City of Portsmouth Planning Board

Property Address: 27 Shaw Road

Application #: LU-23-102

**Re: Application for Lot Line Adjustment Subdivision Approval
Assessor's Map 223, Lots 18 and 18-1
27 Shaw Road and Walker Bungalow Road
Altus Project No. 5279**

Plan Name: **AMENDED SUBDIVISION AND LOT LINE ADJUSTMENT PLAN TAX MAP 223, LOTS 18 & 18-1**

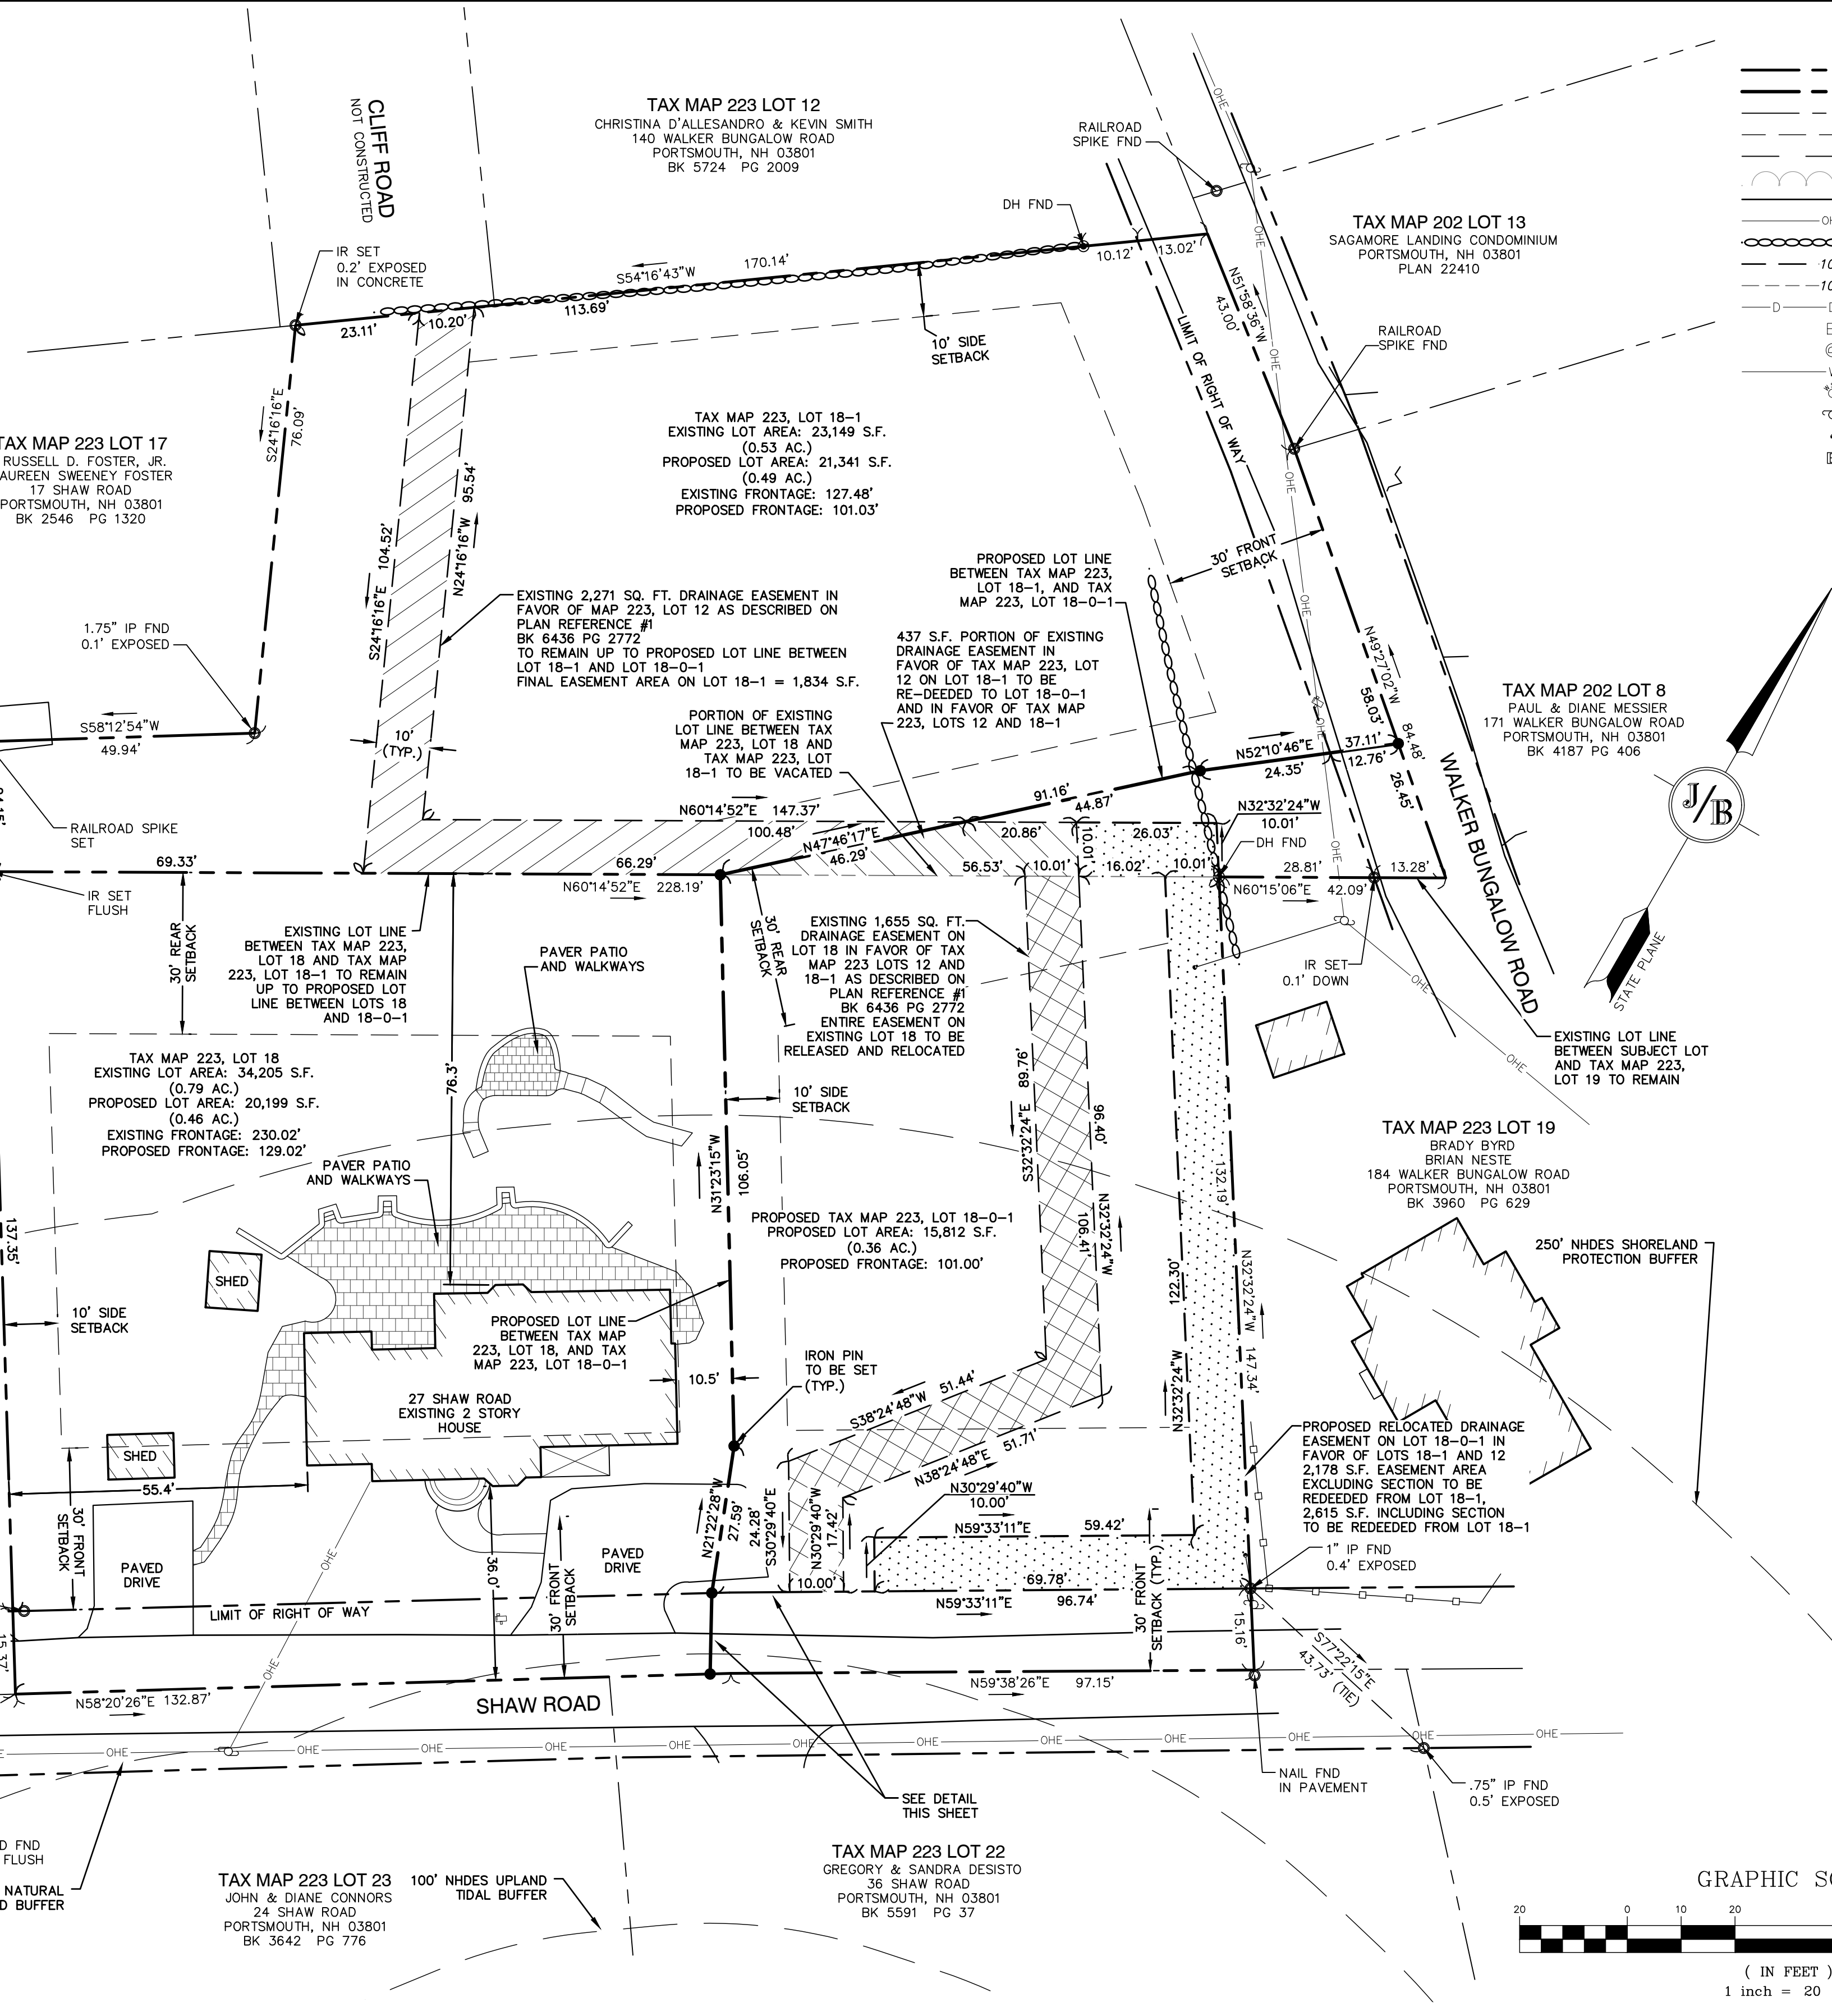
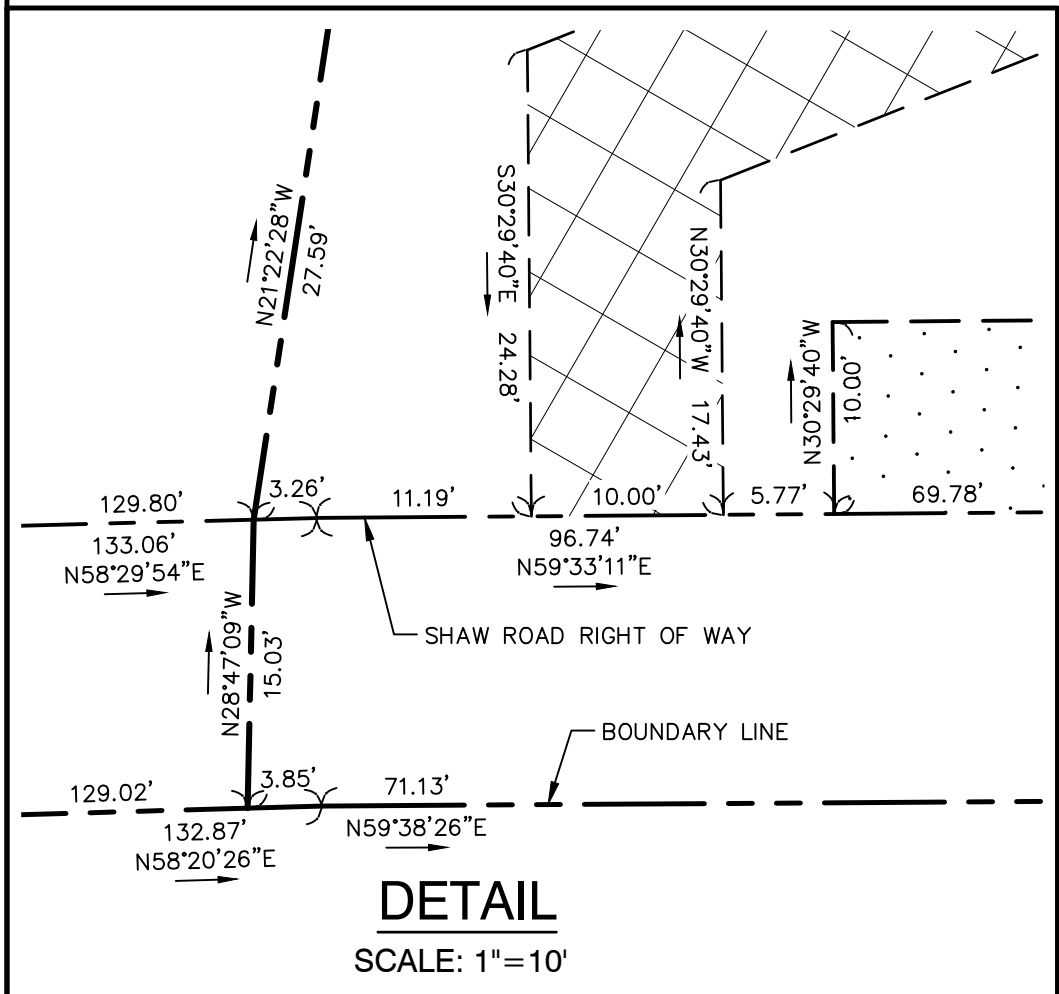
Subdivision Review Criteria	Finding (Meets Standards/ Requirements)	Supporting Information (provided by applicant)
1	Subdivision Rules and Regulations III. D. 1 The Board shall act to deny any application which is not in compliance with Section IV or V as appropriate. SECTION IV - REQUIREMENTS FOR PRELIMINARY PLAT	Meets	A plat was initially submitted August 28, 2023 based on TAC August 1, 2023 review and approval.
2	SECTION V - REQUIREMENTS FOR FINAL PLAT	Meets	A digital format of the final subdivision will be submitted to the City's GIS department upon final approval.
3	SECTION VI - GENERAL REQUIREMENTS	Meets	The application was recommended for approval on August 1, 2023 at the Technical Advisory Committee Meeting.
4	SECTION VII - DESIGN STANDARDS	Meets	The application was recommended for approval on August 1, 2023 at the Technical Advisory Committee Meeting with the following stipulations: <ul style="list-style-type: none"> 1. The lot lines and setbacks need to be adjusted based on the frontage.

1. The setbacks have been corrected. We are now depicting a rear setback and a left side yard setback from Shaw Road. We have also modified the front yard setback from edge of the Shaw Road right-of-way for both lots.
2. The Stormwater Management Plan, Sheet C-1 depicts the locations of the stormwater management devices. Notes 9 and 10 describe the individual treatment devices.
3. Note 17 on Sheet A1 confirms the requirement that the Owner shall submit reports to DPW annually to confirm that the infiltration devices are working properly.
4. The stormwater maintenance management plan and design will be updated once a building program is identified and prior to the issuance of a building permit.
5. The locations and the sizes of the existing utilities have been field confirmed by Altus.

TITLE:
STORMWATER MANAGEMENT PLAN

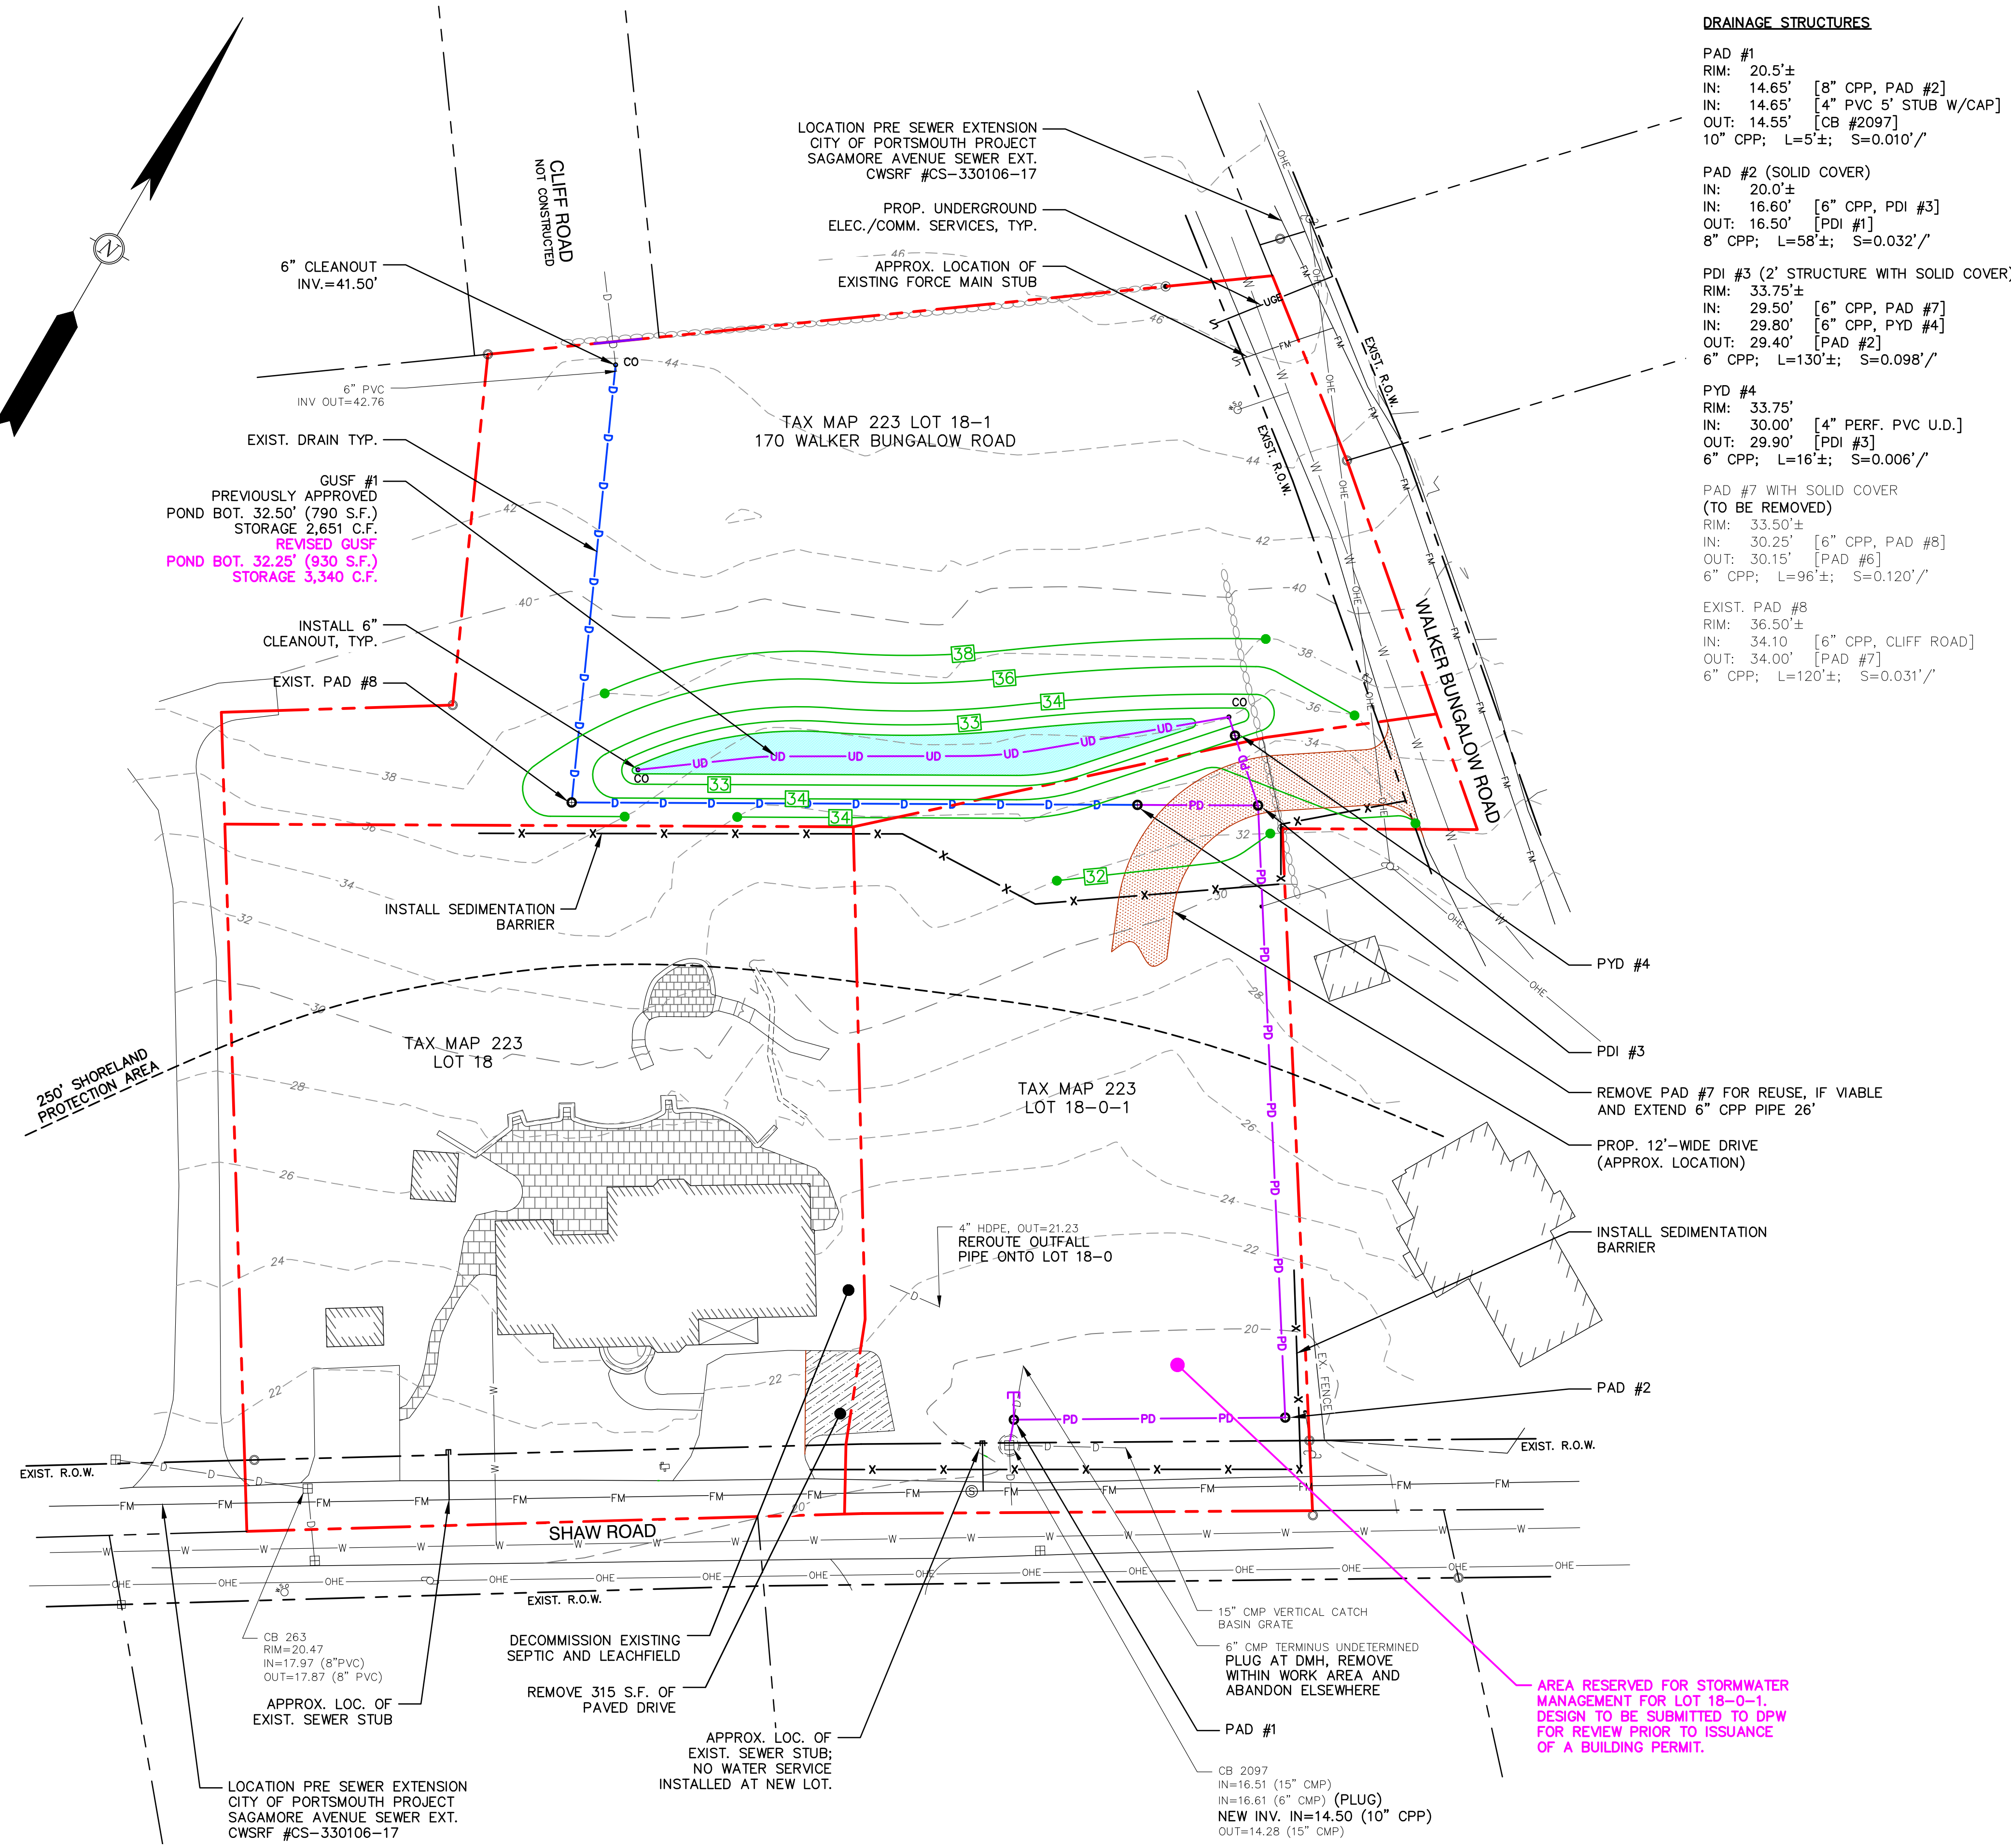
Subdivision Review Criteria	Finding (Meets Standards/ Requirements)	Supporting Information (provided by applicant)
			<p>[Completed]</p> <p>2. The applicant will provide a stormwater management note on plans describing the location and requirements of the rain garden prior to PB approval. [Completed]</p> <p>3. The applicant will provide a note on plans indicating that regular maintenance reports for the infiltration ponds will be submitted to DPW. [Completed]</p> <p>4. A stormwater maintenance management plan shall be updated and provided prior to PB approval. [Completed]</p> <p>5. Correct the size and location of the utilities and drain on plans. [Completed]</p>
5	<u>Other Board Findings:</u>

Site conditions on Lot 18 will remain unchanged except for the removal of 319 square feet of paved driveway, thereby reducing the lot’s runoff. The grass underdrain soil filter (GUSF) on Lot 18-1 was reshaped to accommodate the revised lot configuration. The GUSF a larger infiltration bottom area and storage capacity than previously approved, thereby providing additional stormwater treatment and reducing runoff to the City’s closed drainage system.
